<b>Delegated Report</b>		<b>Analysis sheet</b>	<b>Expiry Date:</b>	07/12/2022
		N/A / attached	<b>Consultation Expiry Date:</b>	17/12/2022
<b>Officer</b>			<b>Application Number(s)</b>	
Leela Muthoora			2022/4421/P	
<b>Application Address</b>			<b>Drawing Numbers</b>	
24 Quickswood London NW3 3RS			Refer to decision notice	
<b>PO 3/4</b>	<b>Area Team Signature</b>	<b>C&amp;UD</b>	<b>Authorised Officer Signature</b>	
<b>Proposal(s)</b>				
Erection of a single storey rear extension at first floor level to dwellinghouse (Class C3) (Associated applications at 8 & 9 Conybeare)				
<b>Recommendation(s):</b>		Refuse planning permission		
<b>Application Type:</b>		Householder Application

- 1.1. The proposal seeks permission for an additional storey at first floor level above the existing rear ground floor flat roof. It would be approximately 5.5m wide by 7m deep by 2.7m in height, with an overall height at approximately 5.9m.

Sectional Elevation A

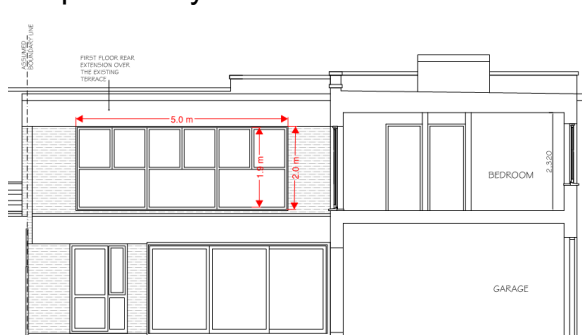
- 3.6. Due to the bulk and scale of the development, the proposal results in a dominant structure of a full additional storey which is no longer subordinate to the host building, is out of scale with the neighbouring sites and presents an overbearing massing to the enclosed gardens.

- 4.3. The proposed elevation of the extension includes windows floor to ceiling height windows and almost full width, arranged over approximately 5m, facing 26 Quickwood. The existing outdoor amenity space is compact and there is relief for users of the gardens and the lower floor rooms by virtue of the setbacks in the upper floor extensions. While the existing outdoor terrace provides outside space for the dwelling, the proposal would increase the sense of enclosure caused by the proposal and would result in a detrimental impact on local amenity as experienced both in the rear gardens and the ground floor rooms. As shown in the image above, the proposed elevation would be approximately 10.5m from the first-floor conservatory structure at number 26 Quickwood. These separation distances are significantly less than the minimum separation distance of 18m set out in CPG Amenity and therefore mitigation measures should be incorporated to reduce the sense of intrusion of privacy, such as setbacks from the parapet, as with the existing extensions at 8 Conybeare and 26 Quickwood.

- 4.4. The existing rear roof is in use as a terrace and benefits from a parapet wall to the southern side adjacent to the garden, and opposite 26 Quickwood. During the previous application, which was refused, officers advised that the proposals should be revised by setting back the footprint of the extension behind the parapet which would mitigate the developments' impact on sense of enclosure and worsening of the outlook for the occupants of the perimeter block. The opportunity to amend the proposals has not been taken in this subsequent application.
